USR17-0055 CR 2 - Safety Concern

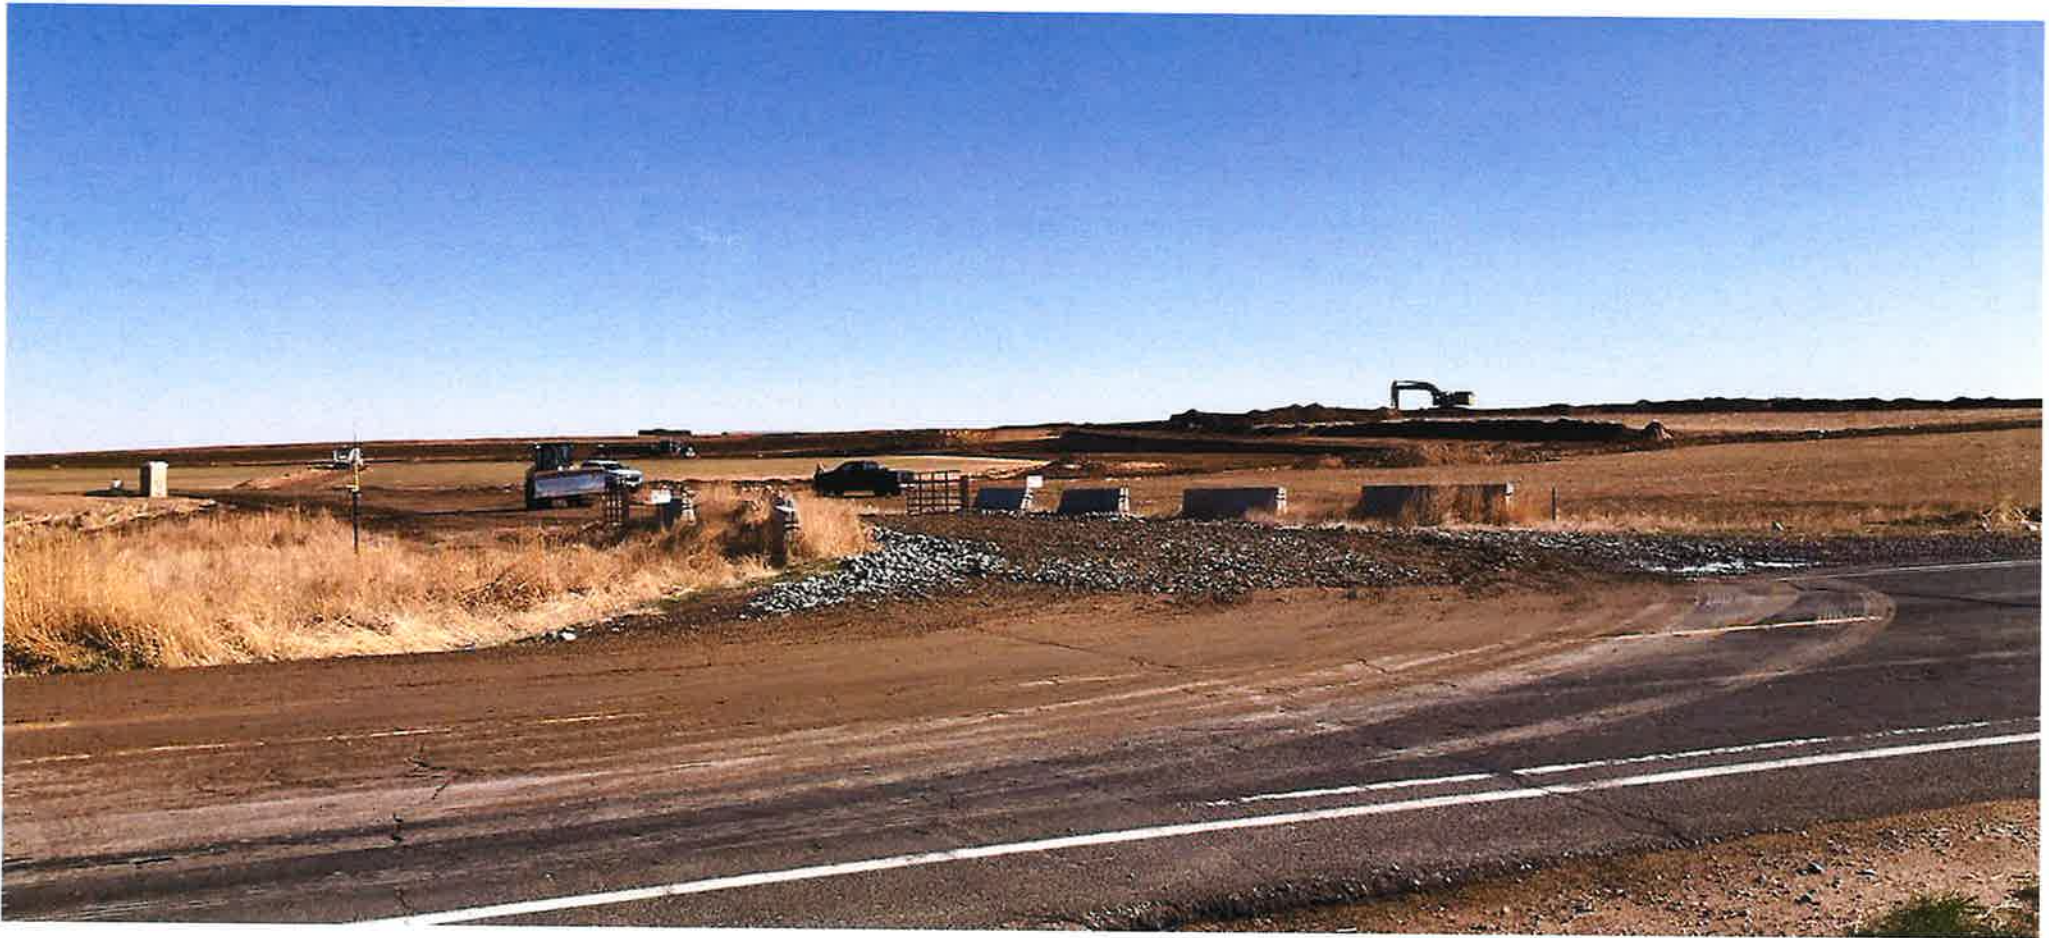
Mining operation appears to be on the east side of the access point not the west side as shown on the DRMS document.

Mud on the road needs to be cleaned up.
Tracking control needs to be installed.
